PEACH BOTTOM ATOMIC POWER STATION, UNIT NO. 2

AMENDMENT TO FACILITY OPERATING LICENSE

Amendment No. 79
License No. DPR-44

SAFETY EVALUATION BY THE OFFICE OF NUCLEAR REACTOR REGULATION
SUPPORTING AMENDMENT NO. 79 TO FACILITY OPERATING LICENSE NO. DPR-44

Figure 3.5.1.C Maximum Average Planar Linear Heat Generation Rate Versus Planar Average Exposure

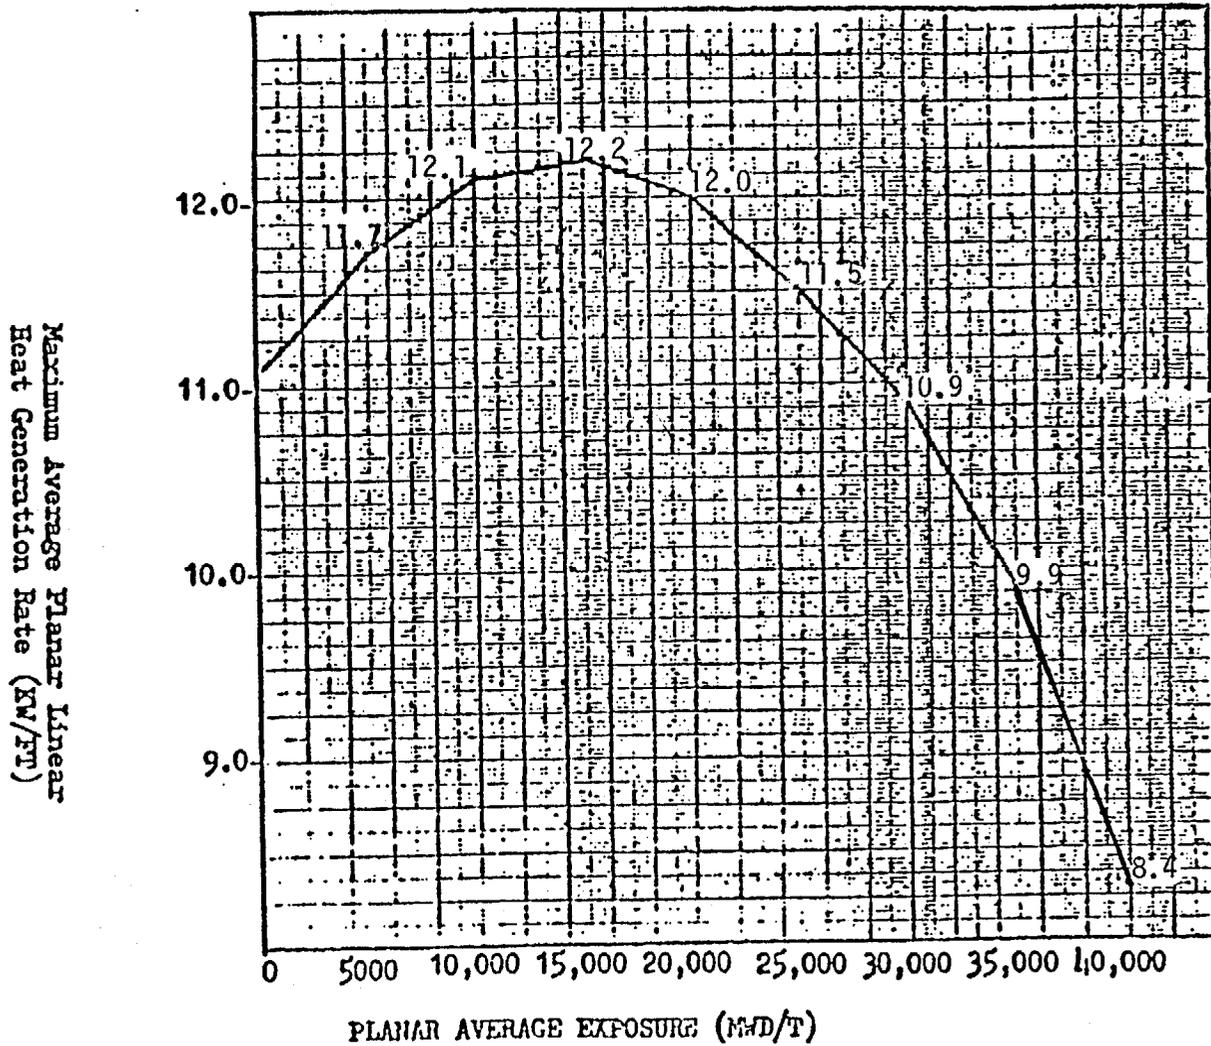
The average level of irradiation of the irradiated fuel from the reactor shall not exceed 33,000 MWD/MTU in accordance with Tables S-3 and S-4 of 10 CFR Part 51.

To assure that the environmental considerations in 10 CFR 51 are evaluated if MAPLHGR limits are extended in the future, we have with the licensee's concurrence, added a note to Technical Specification Figures 3.5.1.C and 3.5.1.D, stating the requirement in 10 CFR 51.20.

Figure 3.5.1.D Maximum Average Planar Linear Heat Generation Rate Versus Planar Average Exposure

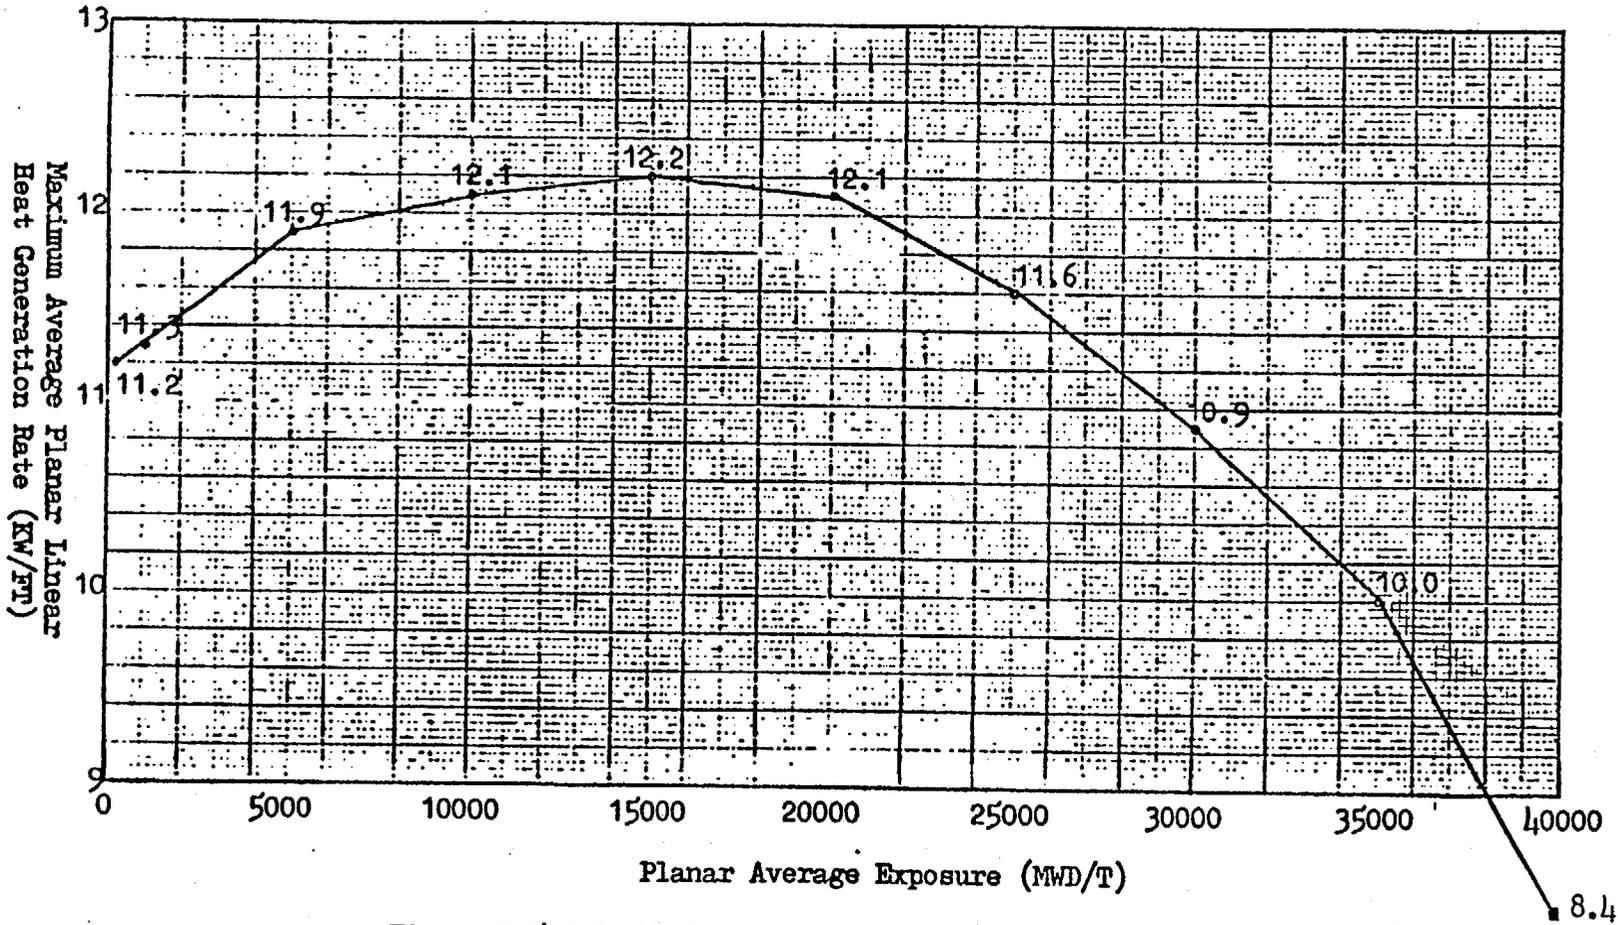
The average level of irradiation of the irradiated fuel from the reactor shall not exceed 33,000 MWD/MTU in accordance with Tables S-3 and S-4 of 10 CFR Part 51.
